## Holland FW351 fifth wheel technical information update

SAF-HOLLAND have recently made design changes to the FW351 fifth wheel. These are as follows:

Product: FW351  
Model: XA-351-A  
Part No: CAST XD-351-H

Ph 03 9743 6799 · enquiries@safholland.com.au · 2011-11-24 · SB-23

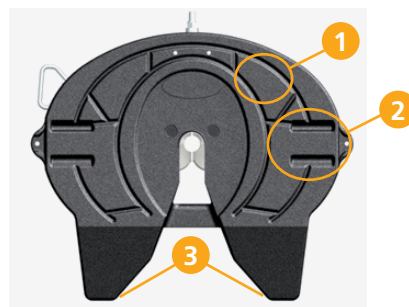
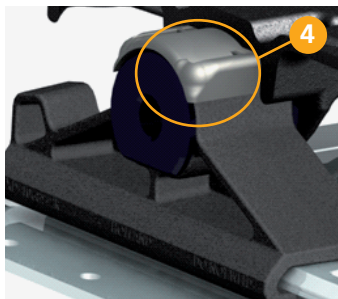
Obsolete (current) FW351 Fifth Wheel

New FW351 Fifth Wheel

Lube Free Pocket Insert

Modular Bolt-On Bracket for Air Release

1. Cast steel top plate surface (no longer machined);
2. Larger grease grooves above pocket area for improved grease retention;
3. Wider throat area, designed to assist drivers when coupling;  
Improves the kingpin target by a further 20%;
4. One piece replaceable lube free pocket inserts which eliminate the need for routine greasing;
5. Provision for modular bolt on air release brackets for simplified the aftermarket installation;
6. Weight savings of 5 kilograms.
